## CIR Response

## CIR #20

Carleton Place Arena  
Renovation and Addition

**CIR #20 Detailed Summary**

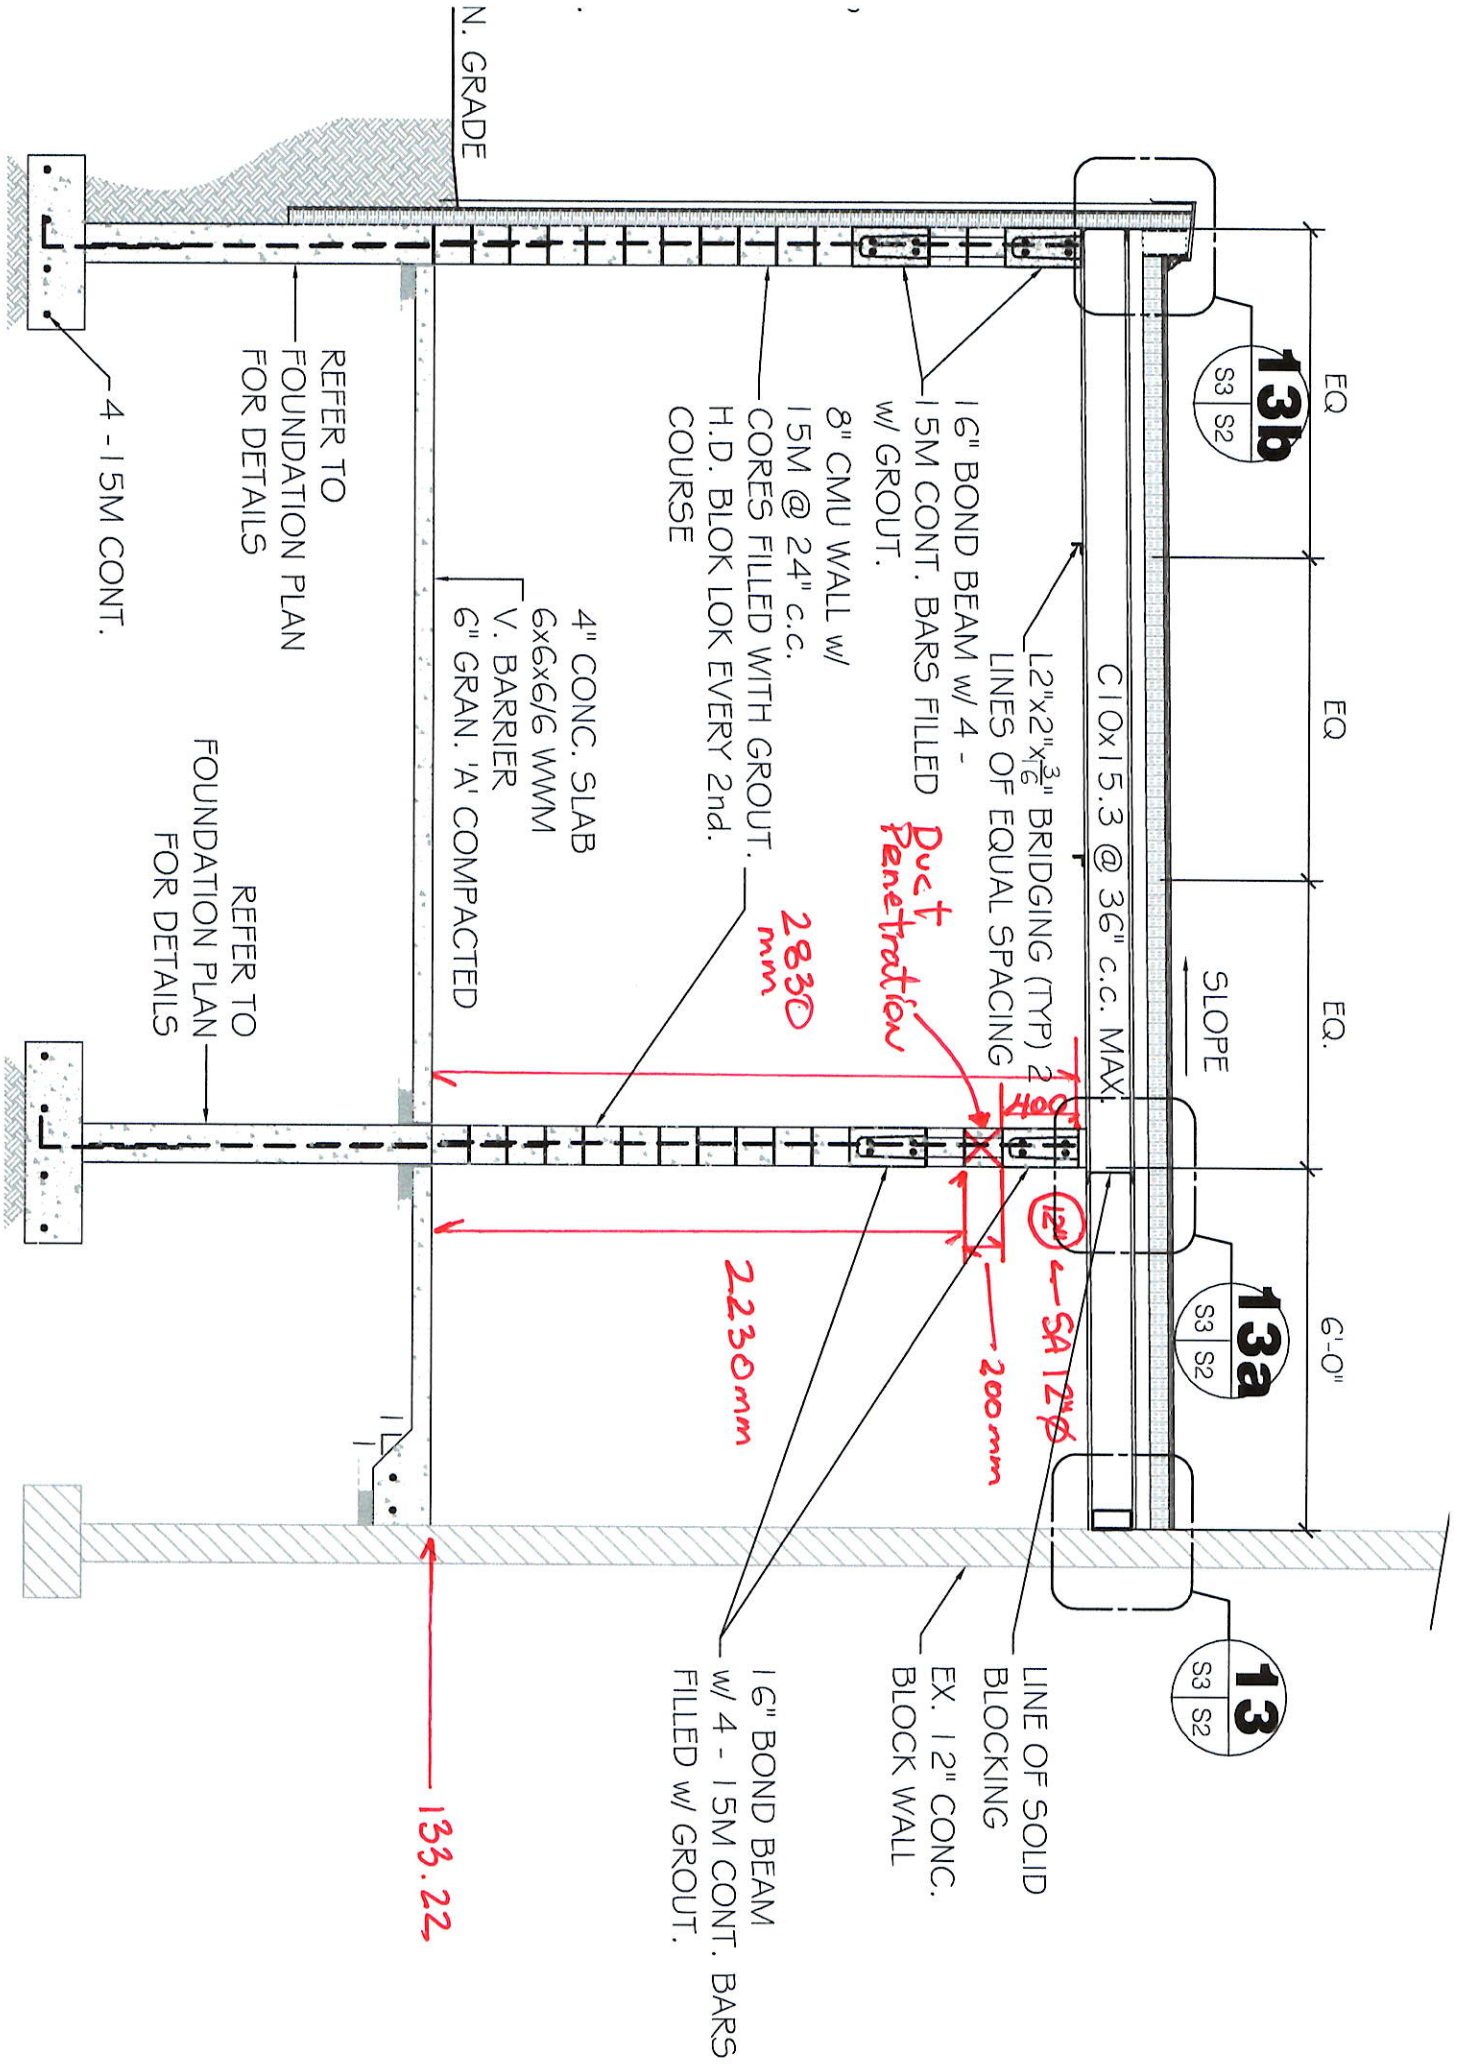
1. Drawing M 101, 4" Sanitary pipe, requires a Venting Stack. There is no wall wide enough to house a 4" pipe through the roof and placing the pipe into an exterior wall would involve installing it through the floor and elbow into an exterior wall having a pipe exposed.

Please advise where to install the vent stack for the underground plumbing?

2. Drawing 1/A8 show a floor drain as a typical detail, but there no information regarding the floor drain in M-101. please advise if a drain is required in the Toilet area?
3. Interior partition walls are detail with a height of 6', please advise how door D 5's would be installed as the height of doors are 84"?

1. The location of the plumbing vent stack has been resolved in Site Instruction #1, attached.
2. Floor drains, in the toilet rooms, were indicated on the architectural drawings. They were not specified on the mechanical drawings. At the time of our site meeting, the associated plumbing had been complete. It was decided to leave the drains in place.
3. D5 is located in wall type W4 which is a full height wall.

1. Ductwork shown in corridor on M102 is to feed into dressing rooms above bond beam between the C-channels.
2. Locate the plumbing vent stack in the corner of the corridor beside Grid Line 10 as opposed to in the adjacent shower room, as previously discussed.
